HISTORIC AND DESIGN REVIEW COMMISSION

HDRC CASE NO: 2023-495
ADDRESS: 134 E MULBERRY AVE
LEGAL DESCRIPTION: NCB 1702 BLK 6 LOT 9, W25 FT OF 10
ZONING: R-4, H
CITY COUNCIL DIST.: 1
DISTRICT: Monte Vista Historic District
APPLICANT: Charles Gonzalez/GONZALEZ LINDA LOPEZ & CHARLES
OWNER: Charles Gonzalez/GONZALEZ LINDA LOPEZ & CHARLES
TYPE OF WORK: Demolition of a designated structure (accessory); conceptual review of new construction (accessory)
APPLICATION RECEIVED: November 15, 2023
60-DAY REVIEW: January 14, 2024 (Applicant requested to postpone from December 20, 2023)
CASE MANAGER: Jessica Anderson

The applicant requests a Certificate of Appropriateness for approval to demolish a detached one-story garage.

The applicant requests conceptual approval of a new detached one-story garage.

134 E. Mulberry
Garage Building
Exterior/Interior Photos

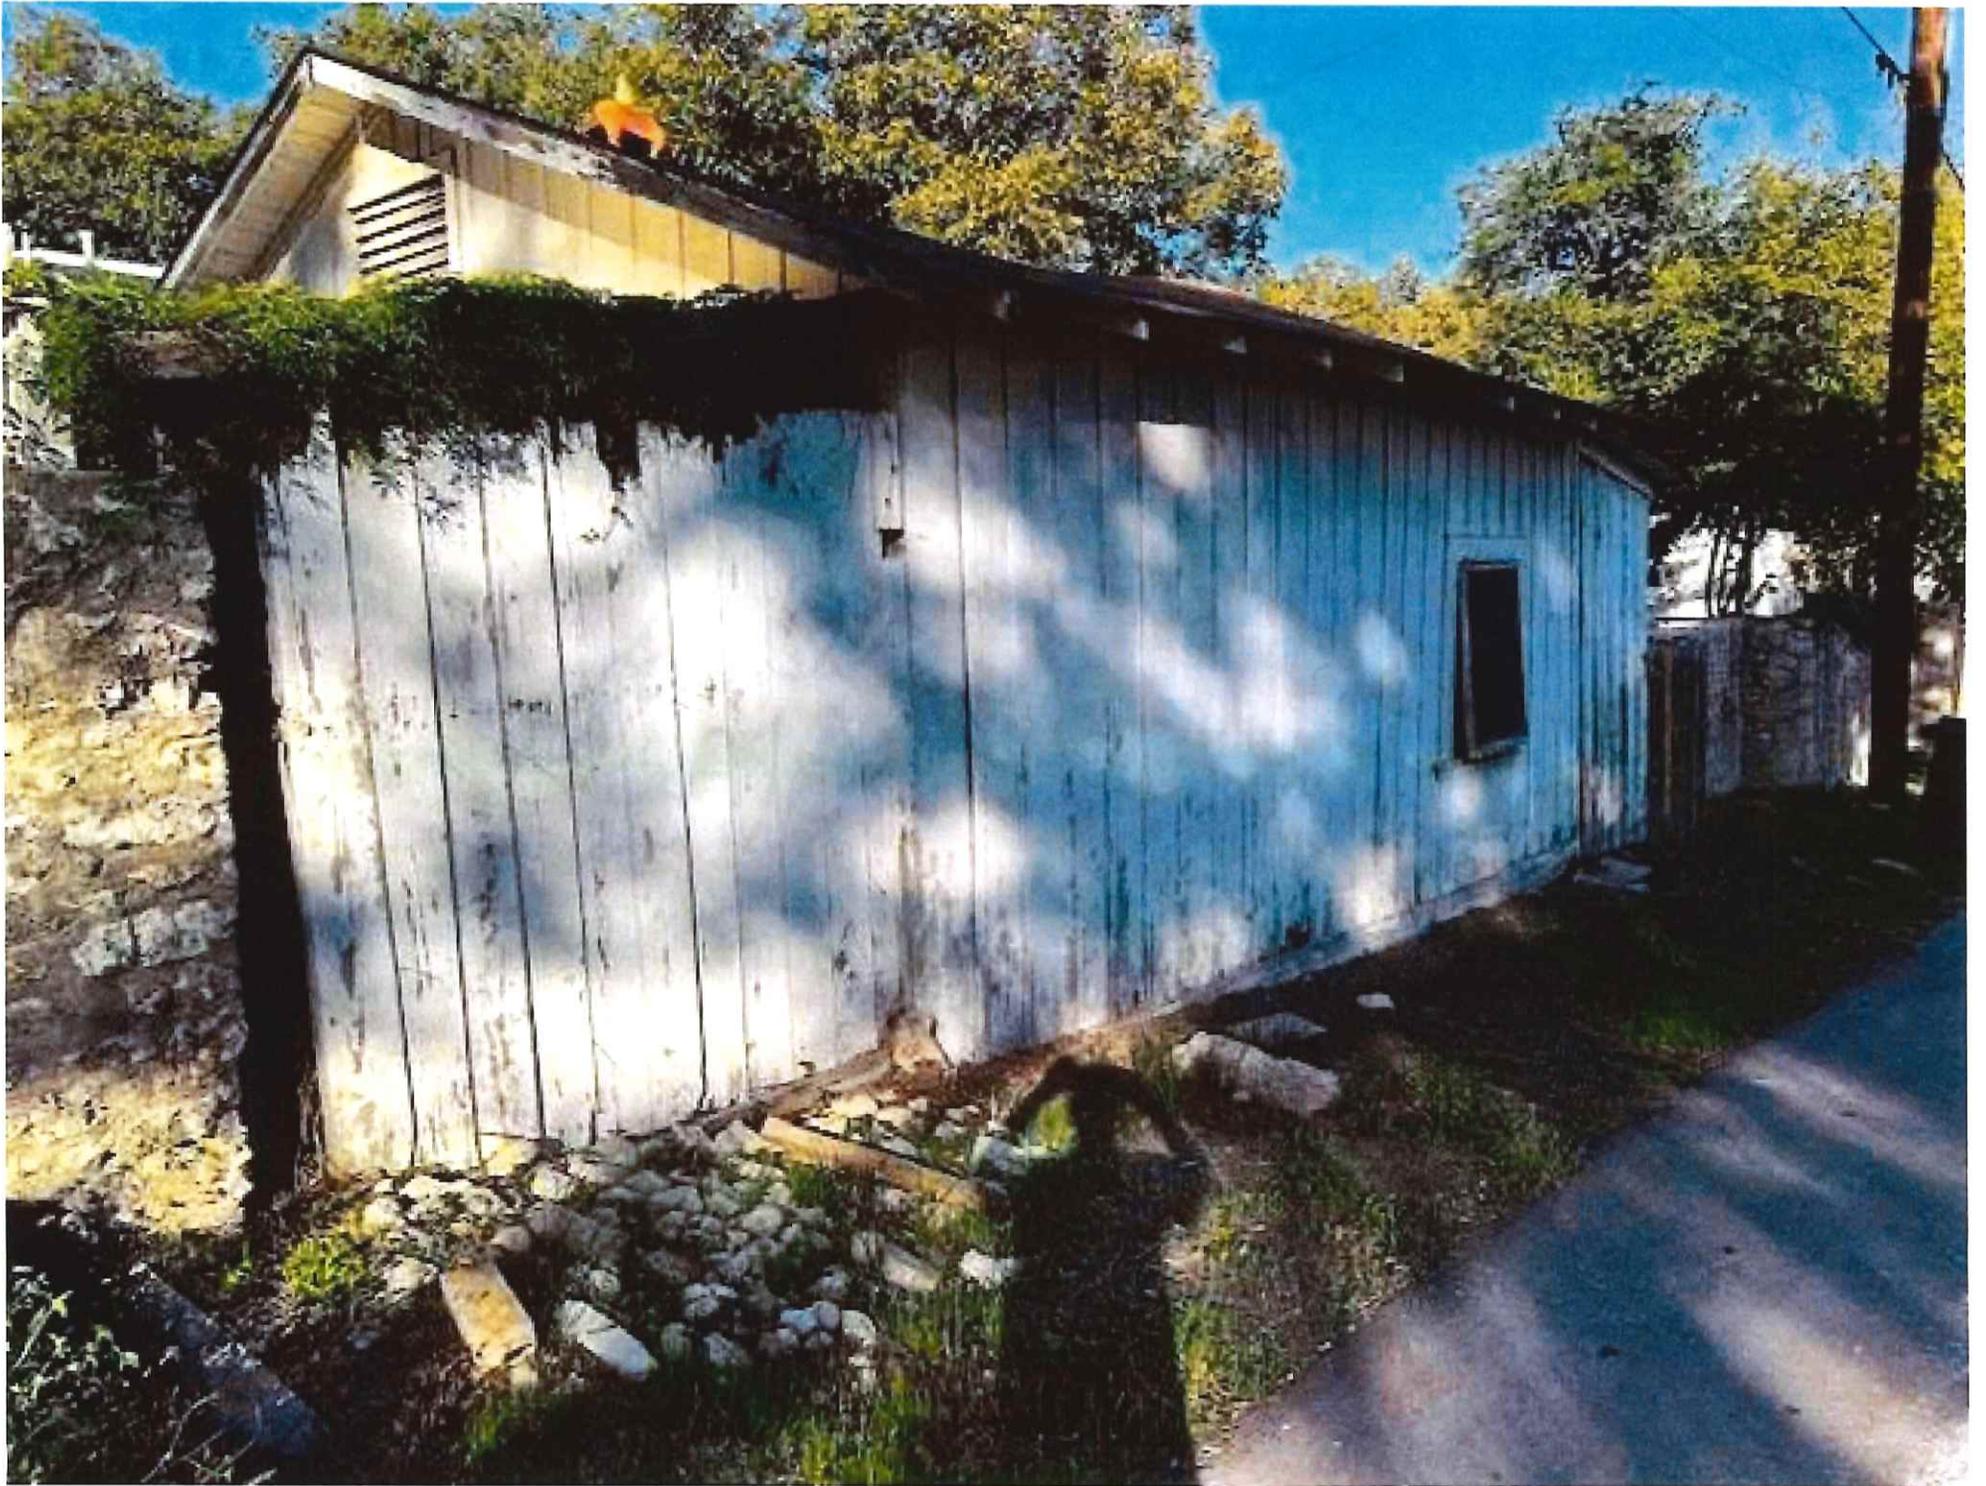
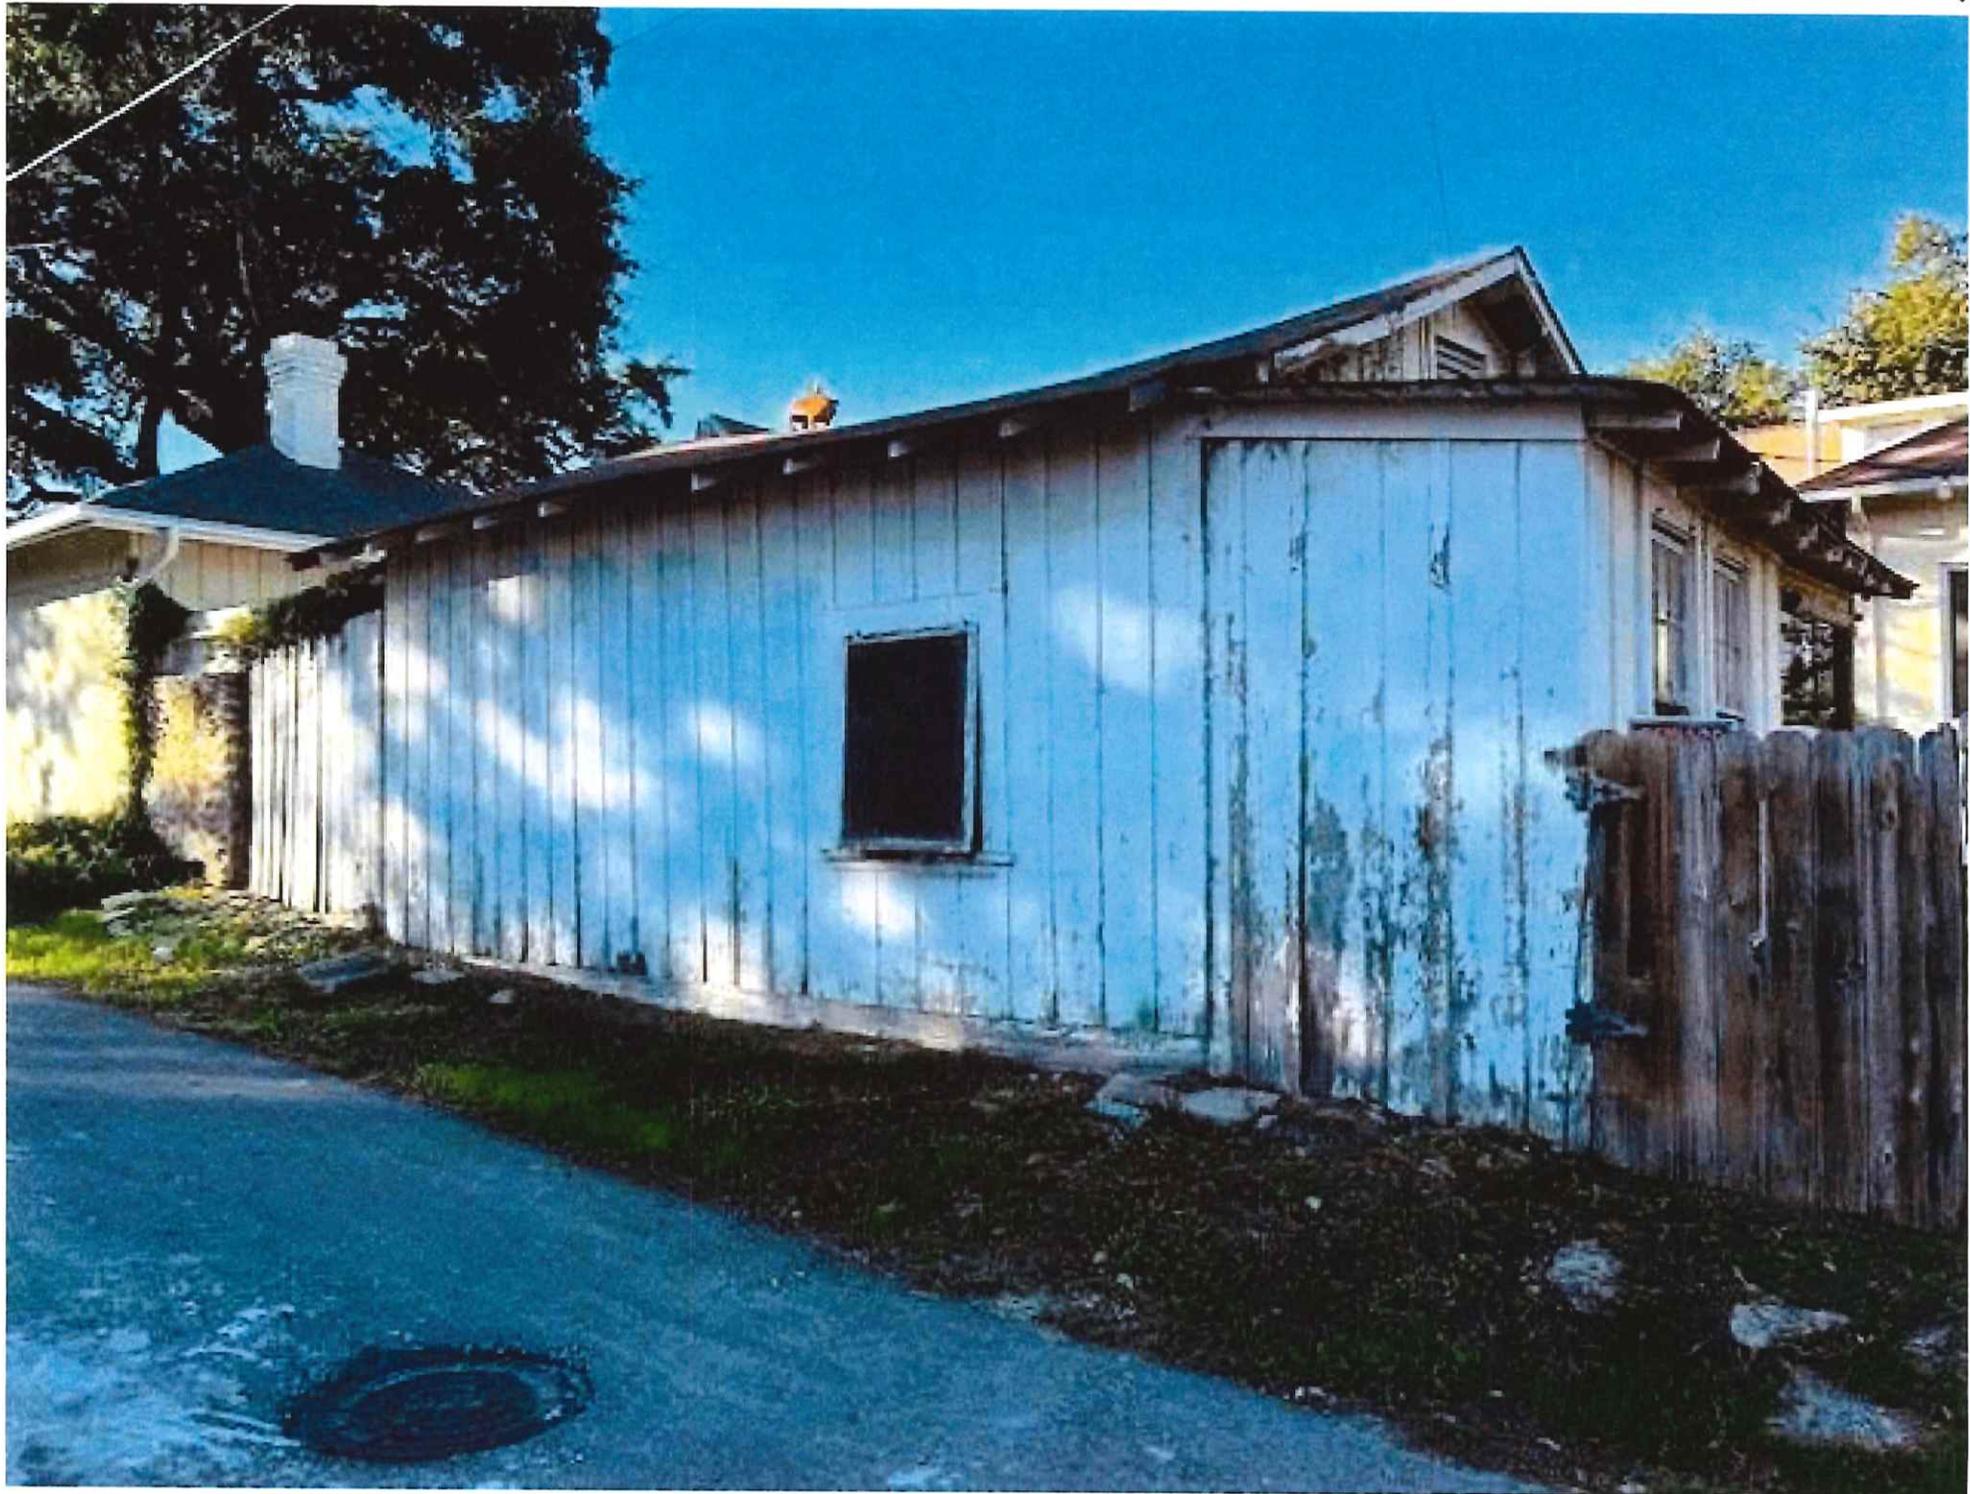
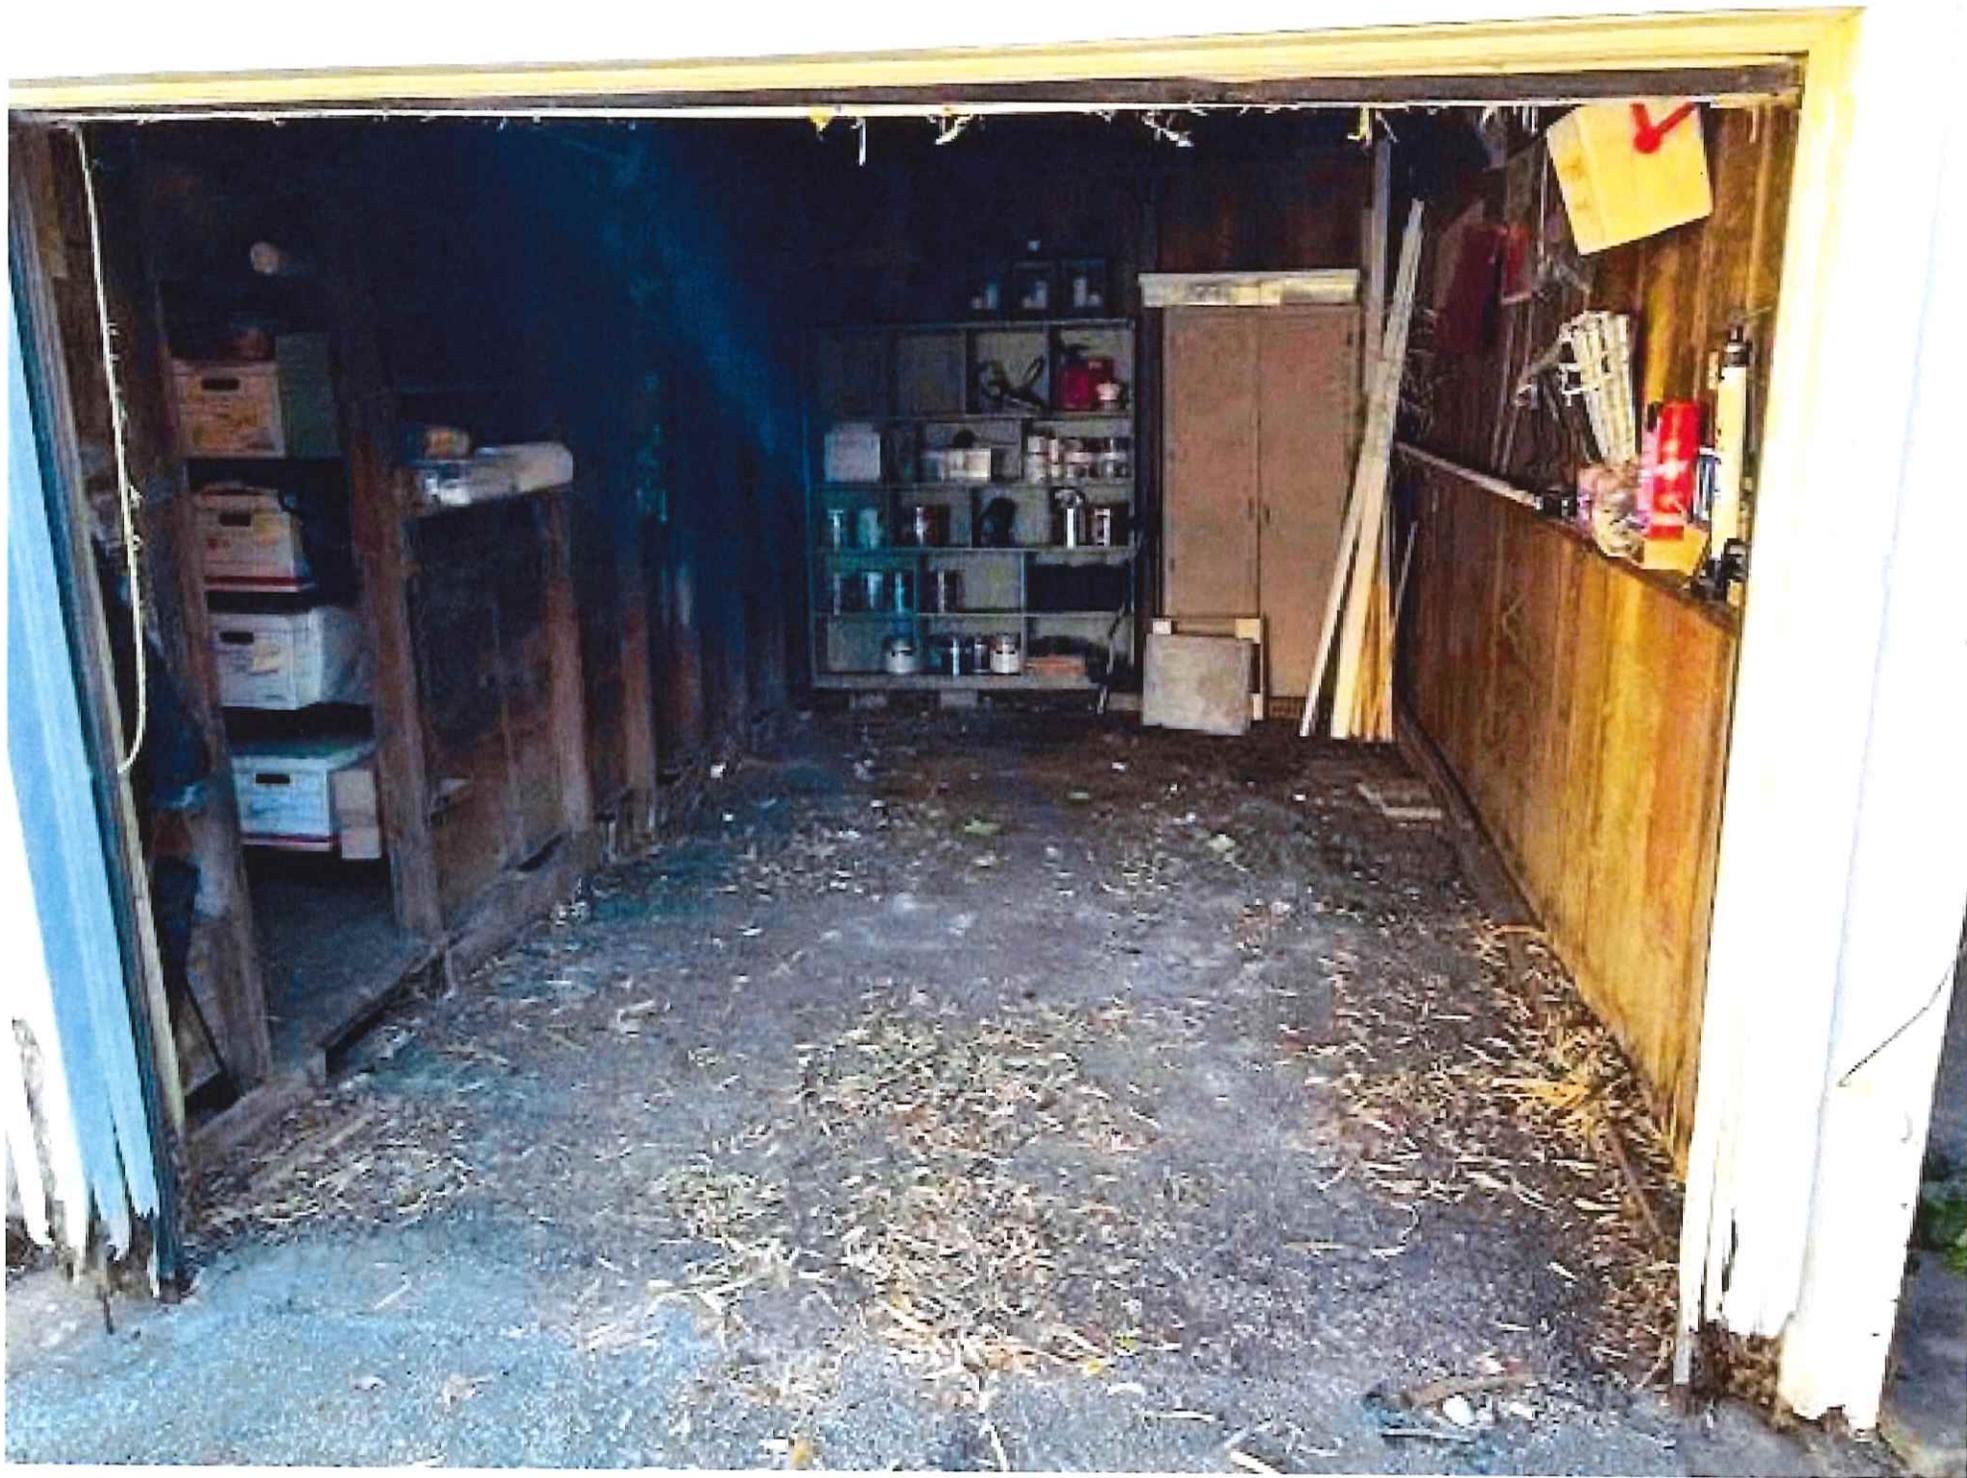
- e. **LOSS OF SIGNIFICANCE:** In accordance with UDC Section 35-614(c), demolition may be recommended if the owner has provided sufficient evidence to support a finding that the structure has undergone significant and irreversible changes which have caused it to lose the historic, cultural, architectural, or archaeological significance, qualities, or features which qualified the structure or property for such designation. The applicant provided annotated photographs of the garage noting sloping roofs, rotting supports, lack of foundation, and general wear to the structure.

1. North side (sloping roof/rotting supports)
2. East side (roof separation and rotting exterior)
3. South side (alley)
4. South side (alley)
5. Garage entrance (sloping roof/rotting supports/
added structure on west side)
6. Garage entrance close-up (no foundation/rotting
supports)
7. Garage floor without foundation/west side walls
lacking supports)
8. Garage ceiling (support beam added due to previous
collapse)
9. West side wall of garage (lack of support beams)
10. East side wall and door to ante room
11. Ceiling to side room attachment to the garage
12. Sink/commode to side room attachment to the
garage
13. Area next to sink/commode
